COSUMNES POWER PLANT (01-AFC-19)

AFC SUPPLEMENT A (Revised General Arrangement)

Submitted by
**SACRAMENTO MUNICIPAL
UTILITY DISTRICT (SMUD)**

March 15, 2002

FIGURE 1.1-3R
SITE PLAN
 COSUMNES POWER PLANT
 APPLICATION FOR CERTIFICATION
CH2MHILL

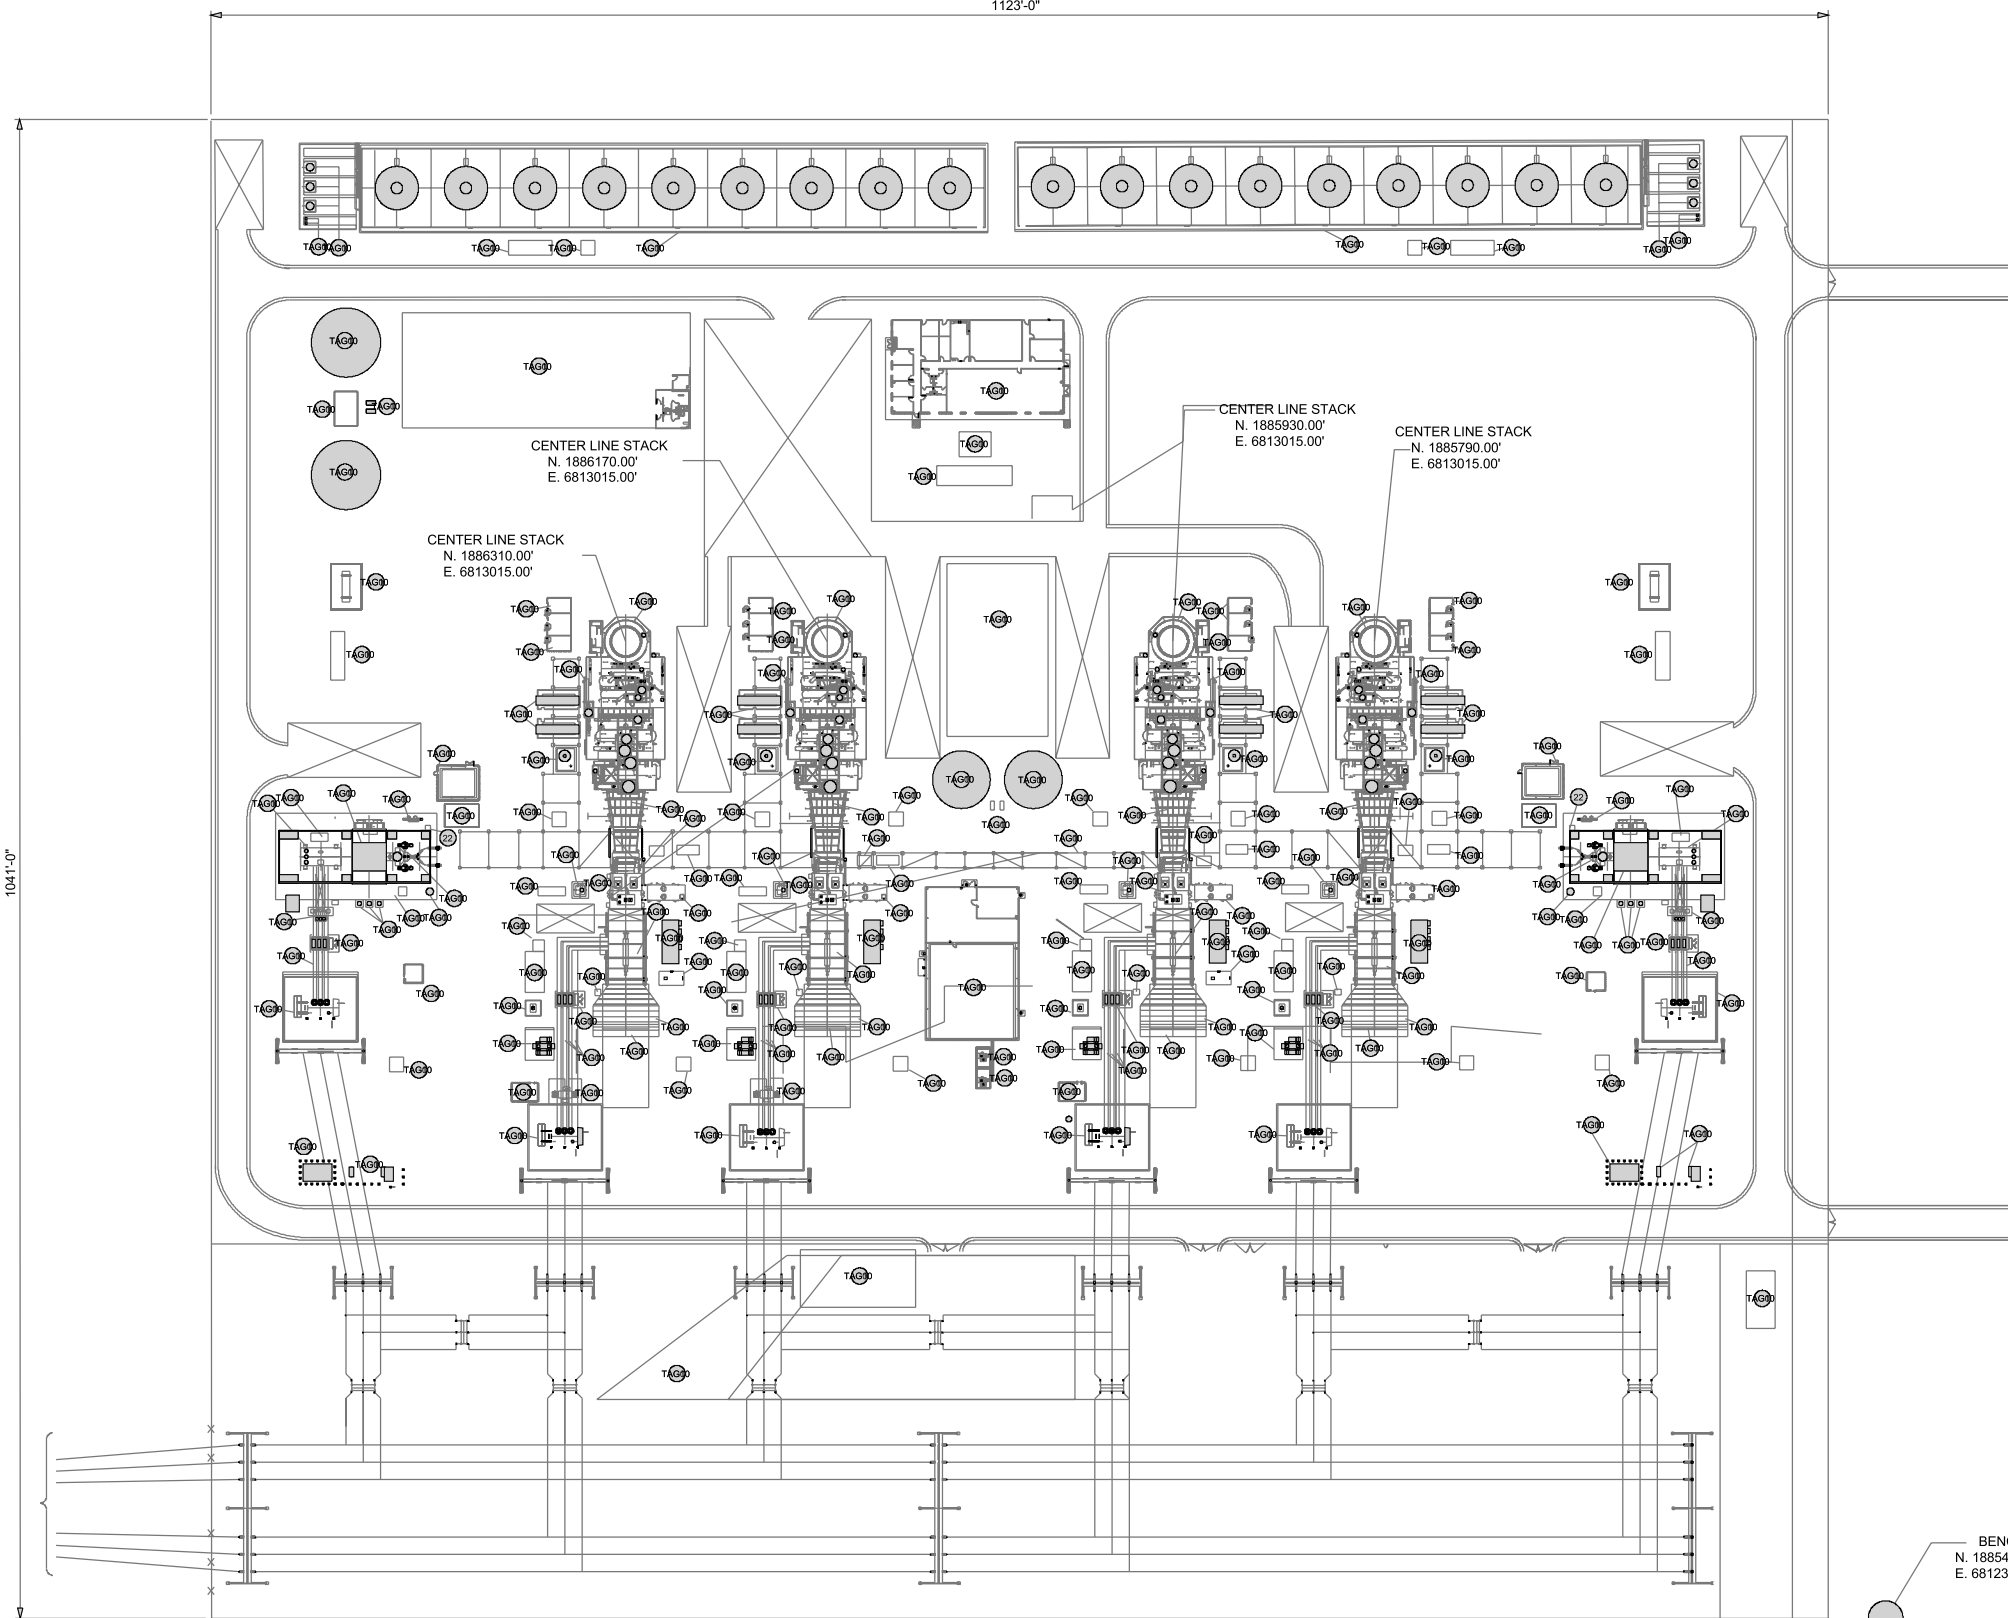
To make operations and maintenance of CPP more efficient, the design engineers have further refined the site plan described in the AFC. It is proposed that the location of the steam turbine generator (STG) be moved from the center of the power block to the southern end of the power block and that the second combustion turbine generator (CTG) be moved from the southern end of the power block to be located south of the first CTG. With this configuration, the plant would have both CTGs at the north end of the power block with the STG to the south. This change would be mirrored in the second phase of the plant. In addition, the height of the HRSG exhaust stacks would be increased from 160 to 165 feet tall.

A new site plan showing the proposed change is presented in Figures 1.1-3R and 2.2-1R. In addition, a new elevation is provided as Figure 2.2-2R. These figures replace those previously submitted in the AFC.

FIGURE 8.5-2R
Proposed Consumnes Power Plant
Expected Plant Noise Emission Contours
During Normal Base Load Operation

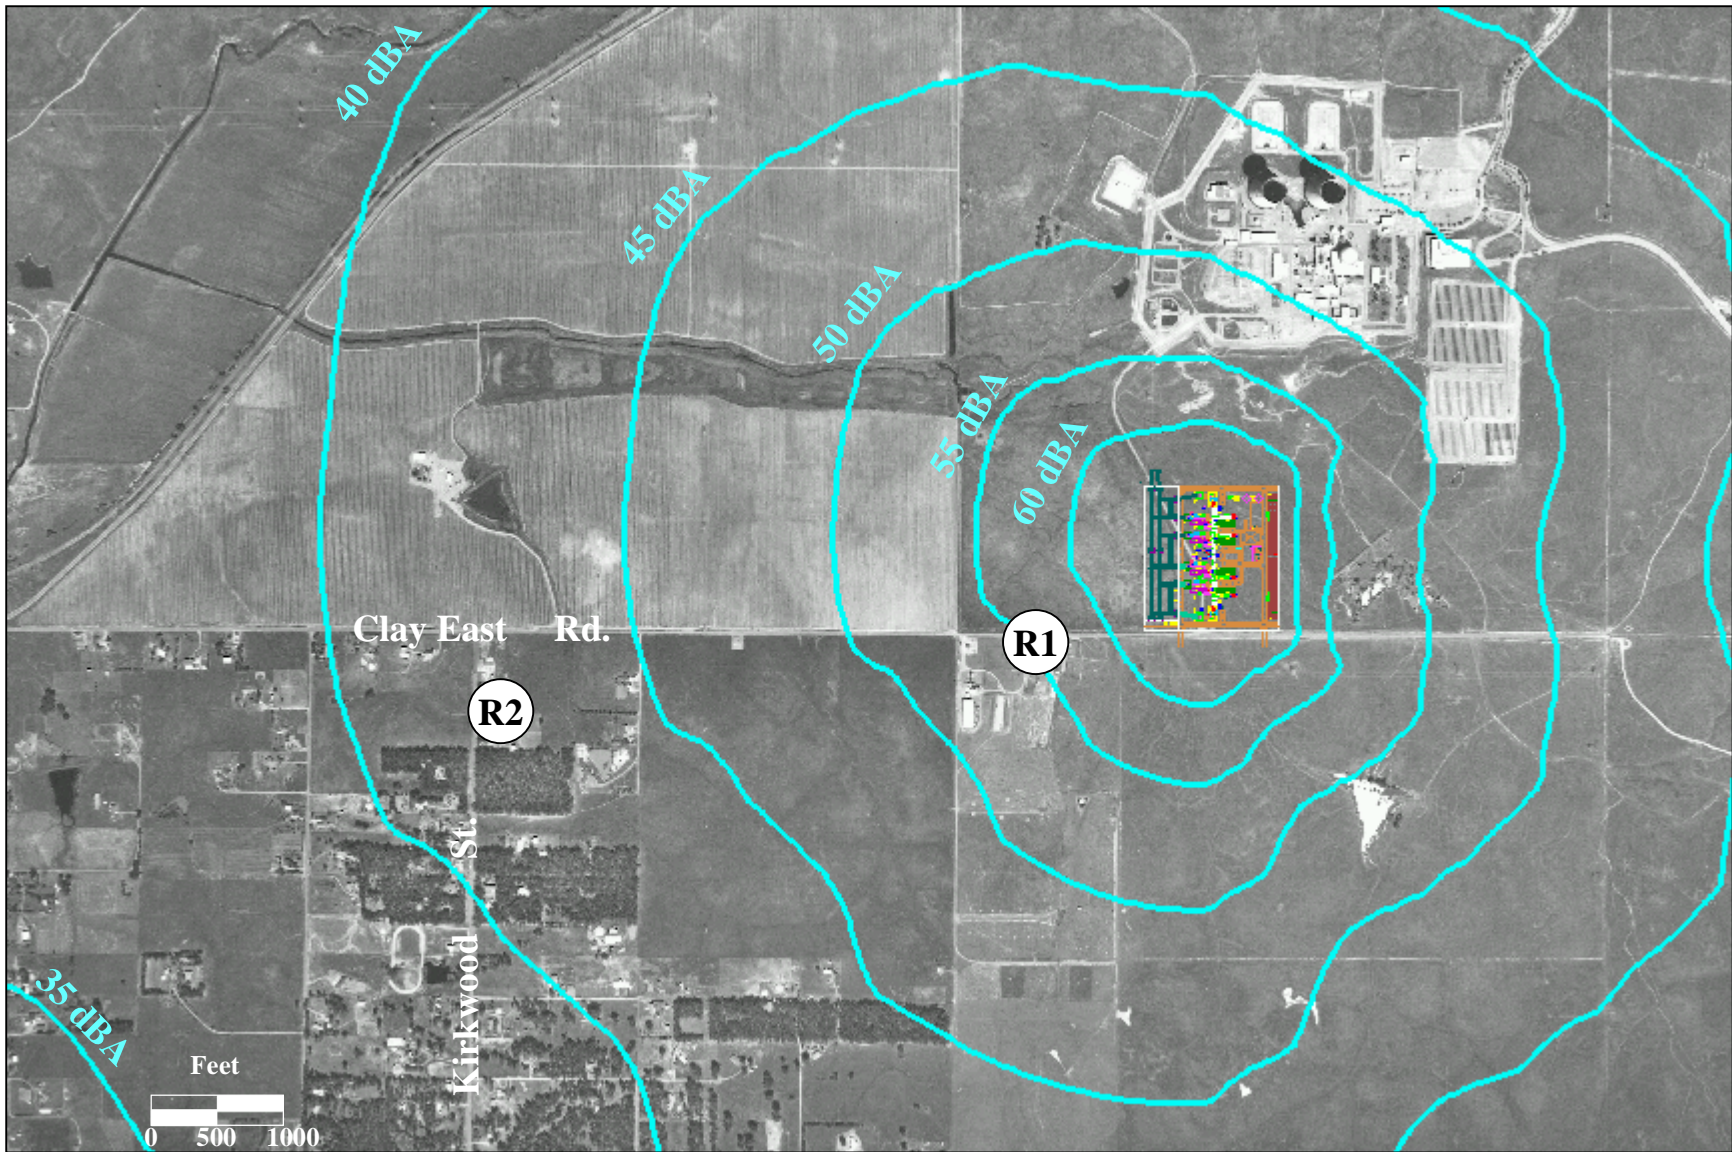
The noise modeling performed in the AFC was rerun to determine if the change in location of the equipment and raising the height of the exhaust stacks 5 feet would adversely affect the noise contours provided in the AFC. The results of the modeled showed that the revised footprint would not substantially change the projected noise contours (see Figure 8.5-2R). In fact, the noise levels would be slightly quieter with the new configuration.

FIGURE 8.11-3bR
KOP 2: SIMULATED VIEW OF PROJECT
COSUMNES POWER PLANT
APPLICATION FOR CERTIFICATION

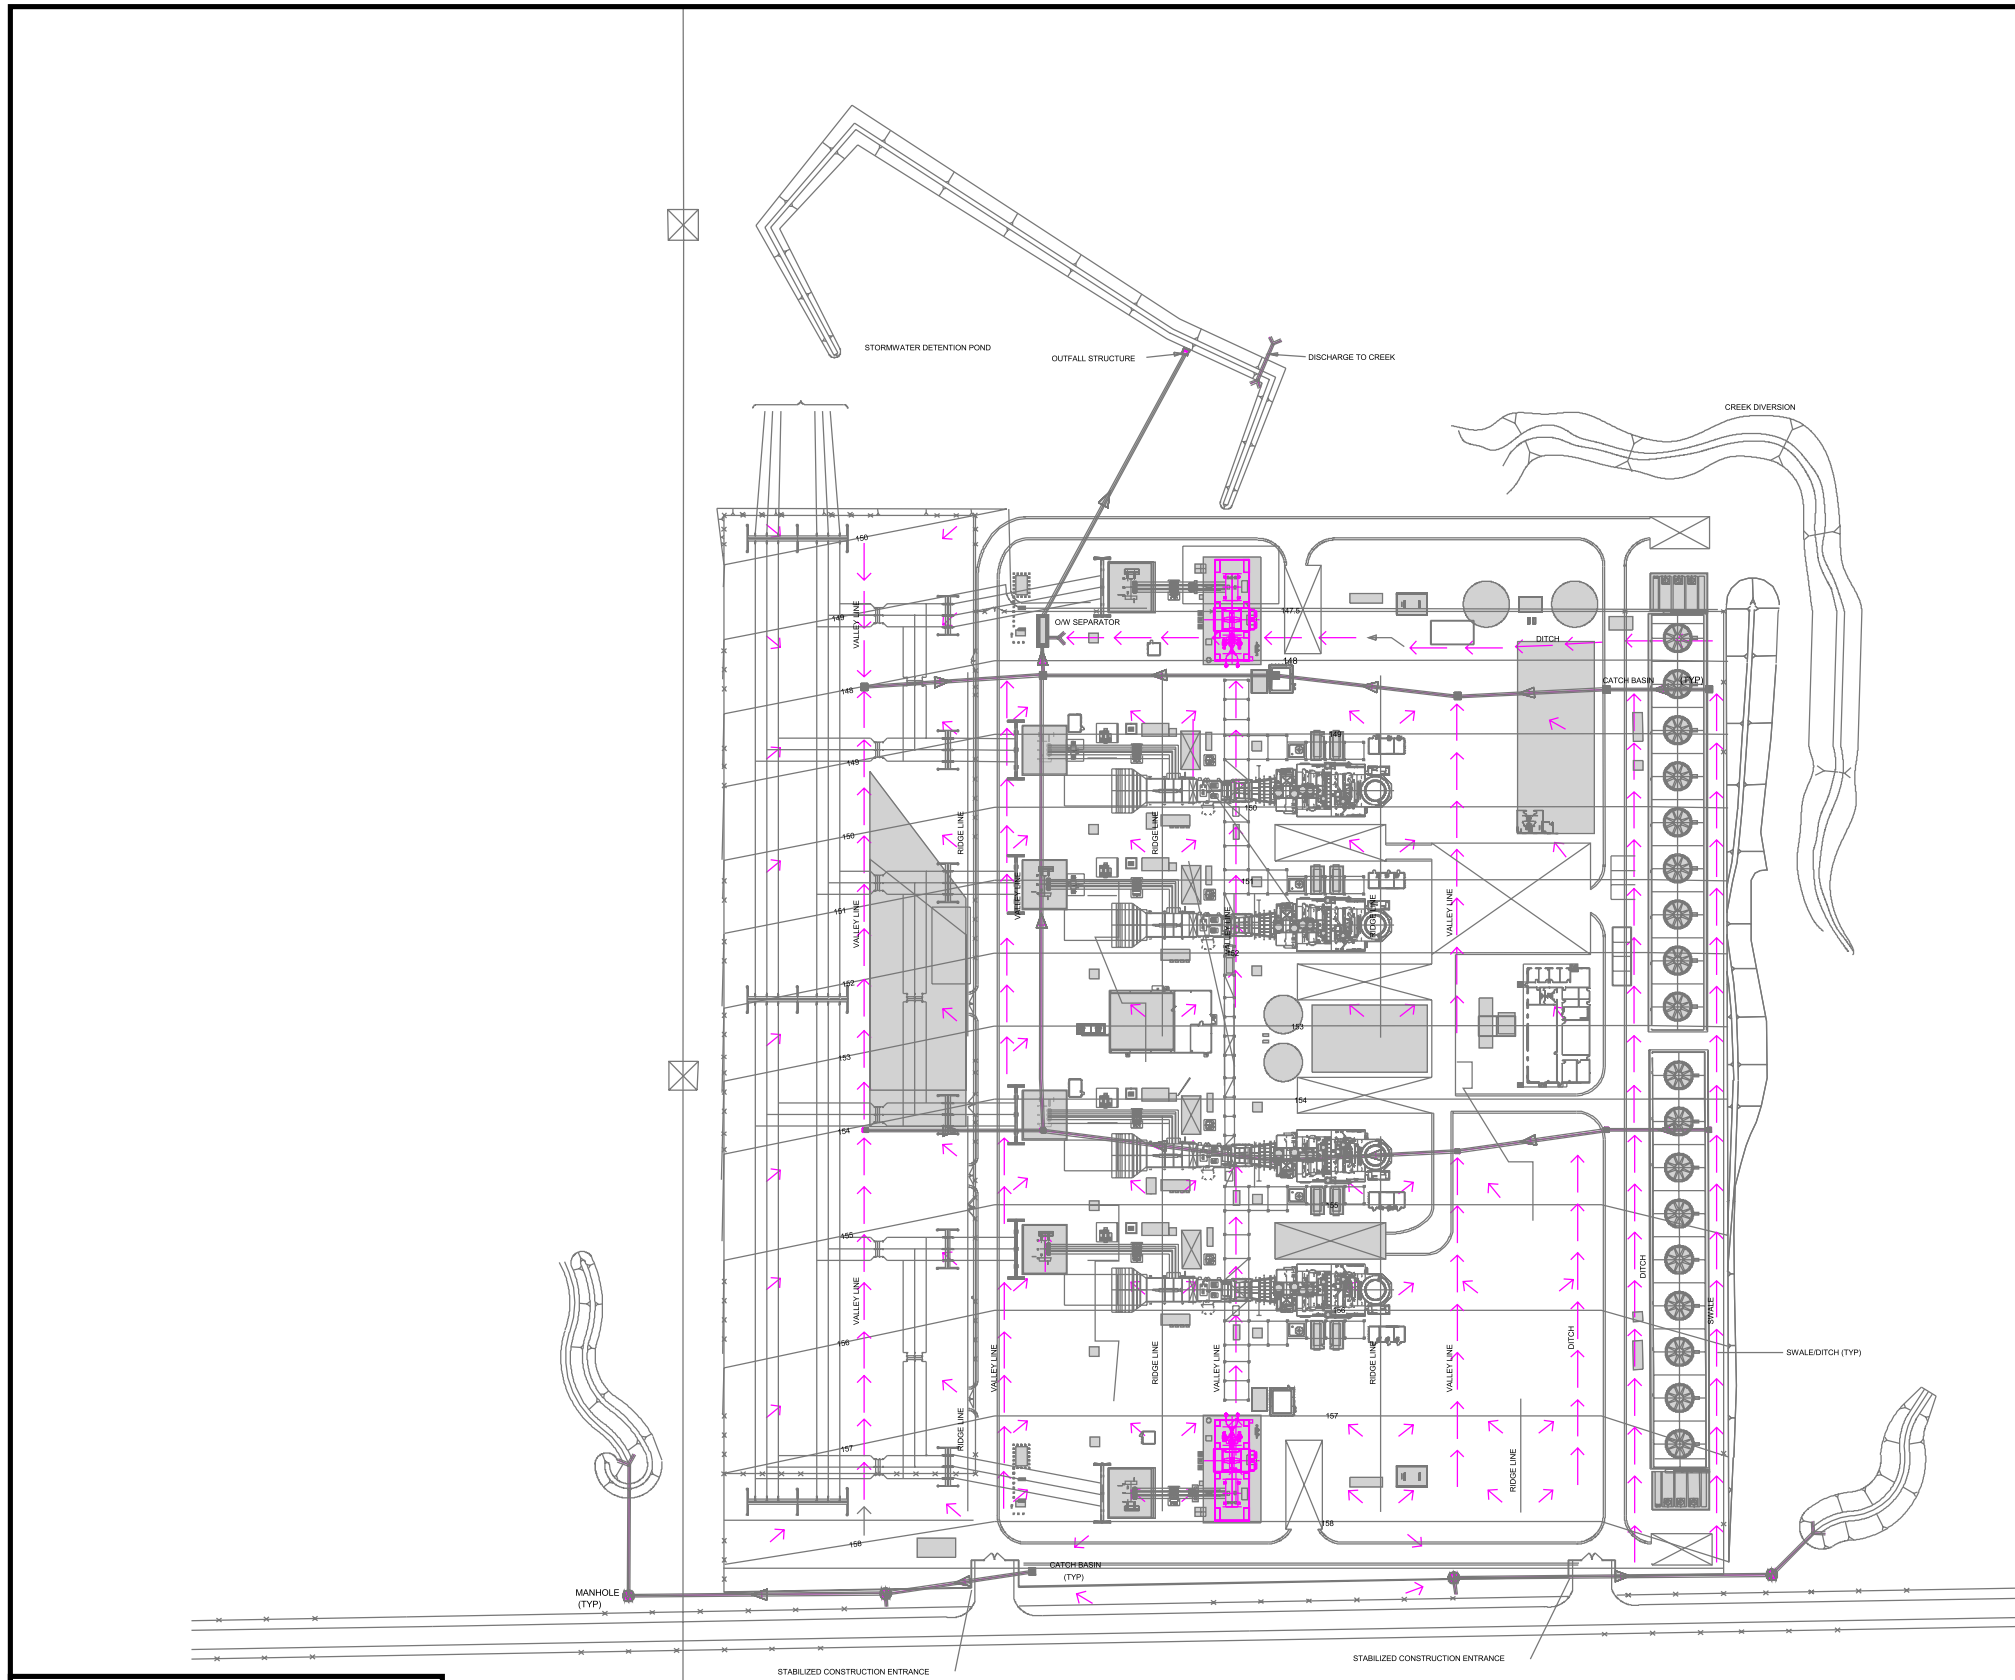
Changing the configuration of the power block would not create any additional impacts from those discussed in the AFC. When comparing the revised simulations (see attached simulations (Figures 8.11-2bR and 8.11-3bR) to the simulations included in the AFC, there are some noticeable differences when viewed side-by-side. However, the effects on the views from both KOP 1 and 2, as shown in the attached revised simulations, would be virtually the same as those presented in the AFC. Therefore, the visual impacts on views from the KOPs resulting from the changed plant configuration would remain adverse but not significant.

Data Request 96 (Set 1) requests that KOPs 1 and 2 be revised to show the proposed single-pole transmission towers. The attached simulations have been revised to show the proposed change in the power block and the single-pole transmission towers (see Figures 8.11-2bR and 8.11-3bR). As shown in the attached simulations, the transmission tower revision would not significantly alter the views from the KOPs, when compared to the simulations included in the AFC.

FIGURE 8.14-4R
GRADING AND DRAINAGE PLAN
 COSUMNES POWER PLANT
 APPLICATION FOR CERTIFICATION
CH2MHILL

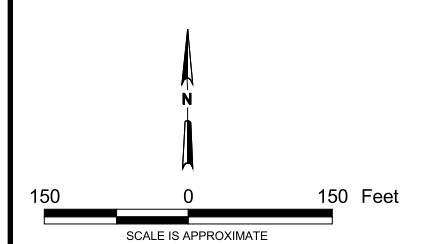
However, it would require a change in the grading and drainage plan for the facility. Therefore, Figure 8.14-4 has been revised. The new figure, Figure 8.14-4R, is attached.
